PECO ENERGY

SUBJECT: Limerick Generating Station, Units 1 and 2  
Application for Approval of Proposed Disposal Procedures  
Request for Additional Information

REQUEST FOR ADDITIONAL INFORMATION

Figure A.1

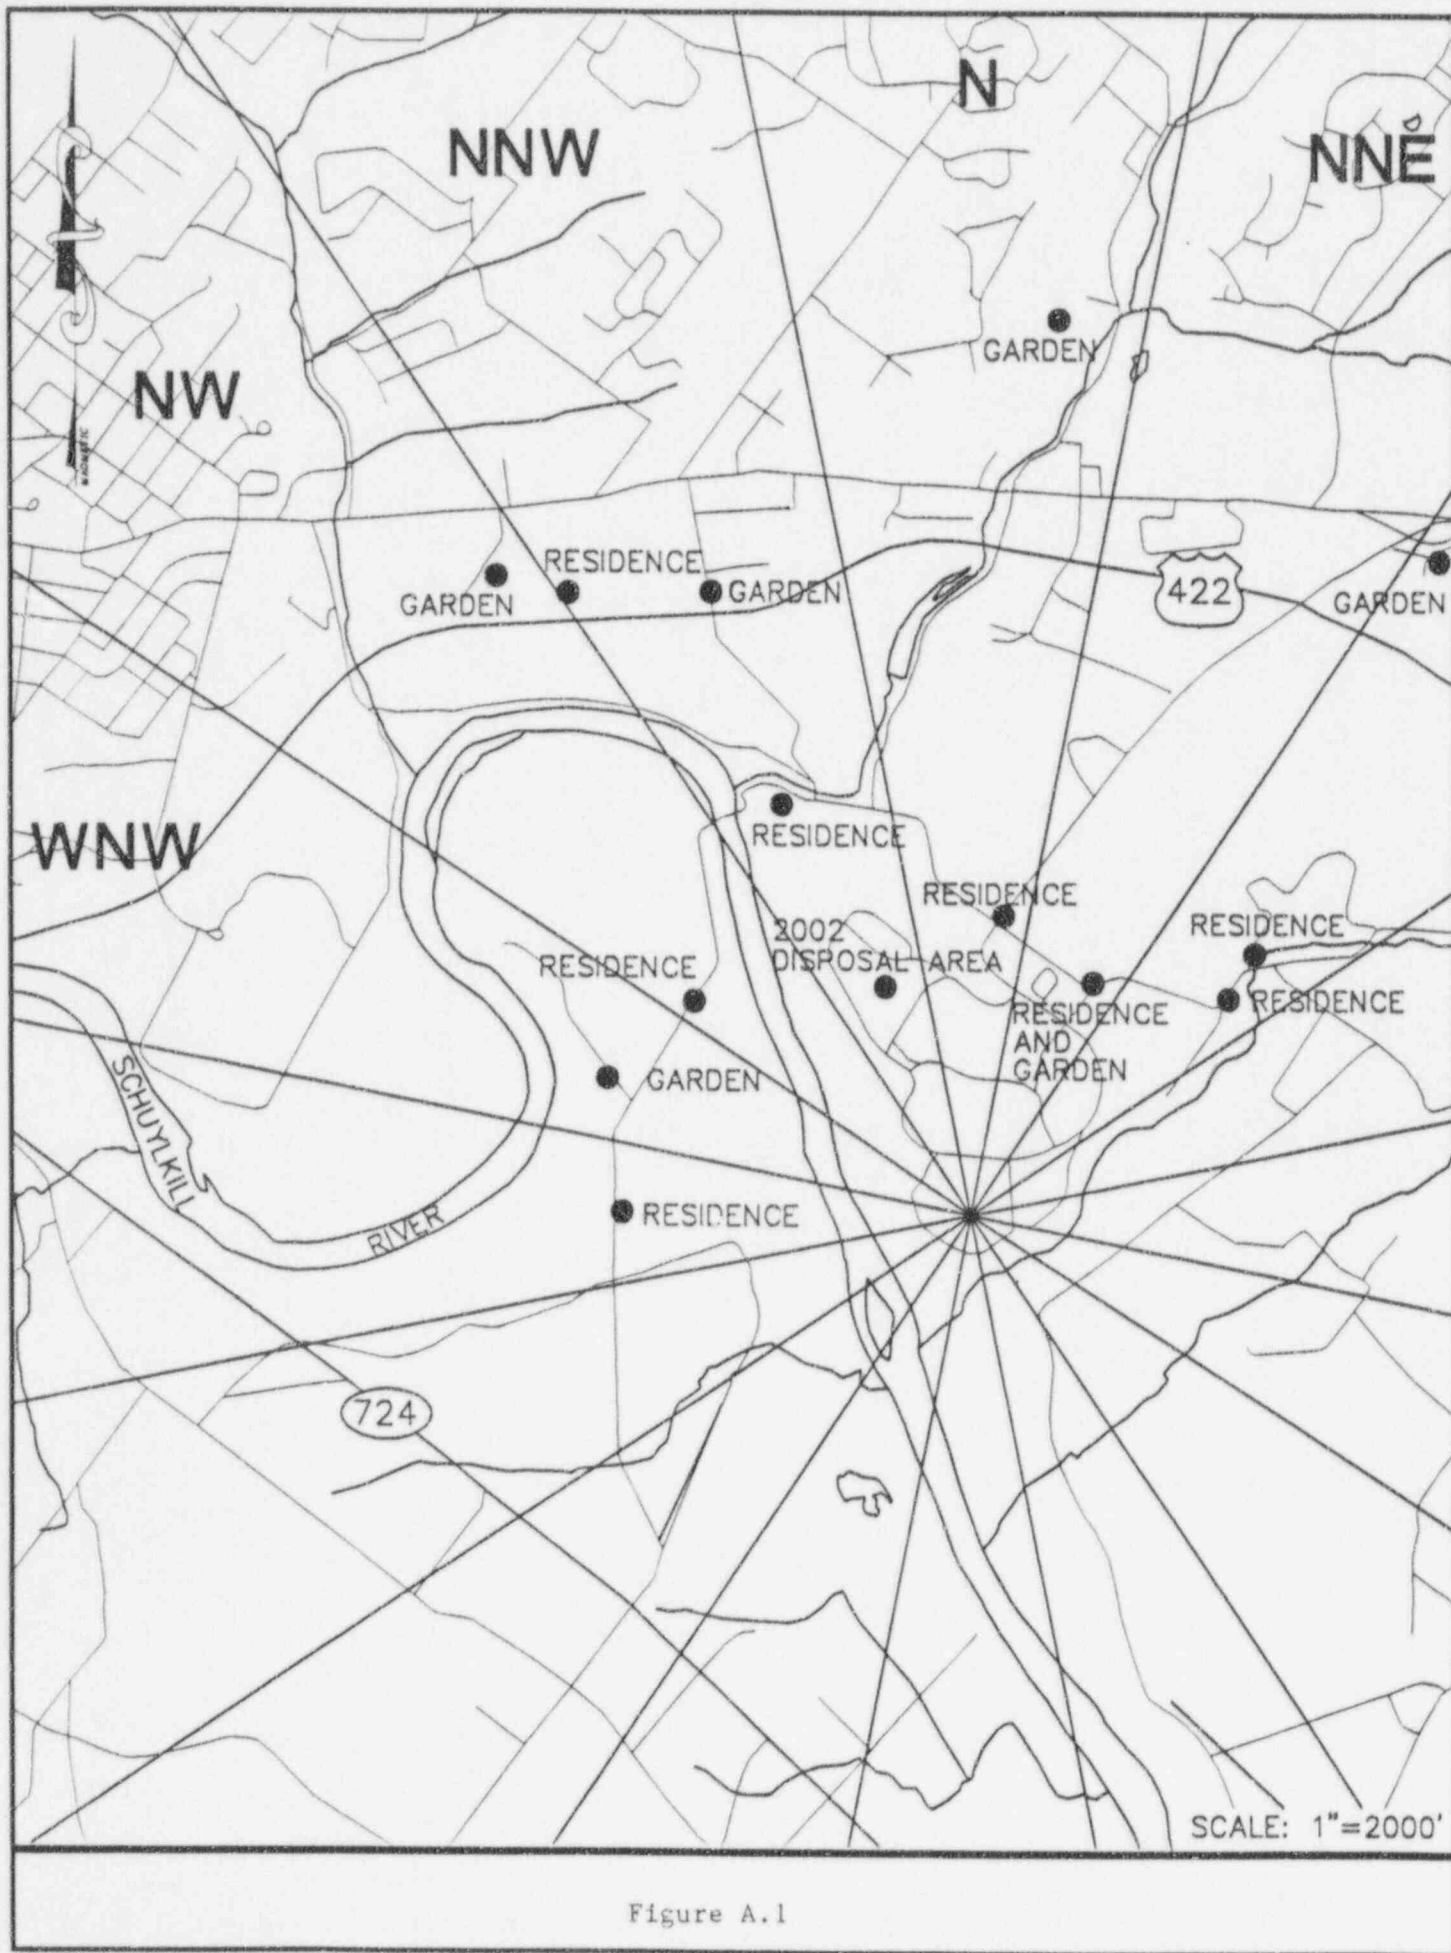
- 1.a What is the designated disposal site? Provide a legible map of the disposal site with compass direction and scale, that includes local land use (e.g., buildings, nearby residences, wells, etc.)
- 1.b Provide a pathway analysis from point of origin to final destination of the disposed contaminated material (see Figure 5.4, "Potentially meaningful exposure pathways to individuals," FES, 1984)
- 1.c In the application the licensee stated that the disposal volume will not exceed a total of 1,120,000 cubic feet. Please specify how the volume originated and how it will accumulate to this maximum volume. What is the yearly projected volume of contaminated waste?

- 1.a Figure A.1 of this Attachment provides the requested information. The nearest residence and garden are depicted in the W, WNW, NW, NNW, N, NNE, and NE sectors. The nearest well is assumed to be located at the nearest residence. Ground water movement is to the SW away from the nearest residence and towards the river. Figure A.2 shows a potentiometer contour map for the Limerick Generating Station Site depicting ground water movement.
- 1.b Figure B of this Attachment provides the requested information. The pathway analysis doses are based on the assumptions that the maximum amount of material (1,120,000 cubic feet) at the maximum concentration (specified in the 10 CFR 20.2002 application for all radioactive nuclides routinely searched for by the LGS effluent program) is placed in the designated area.
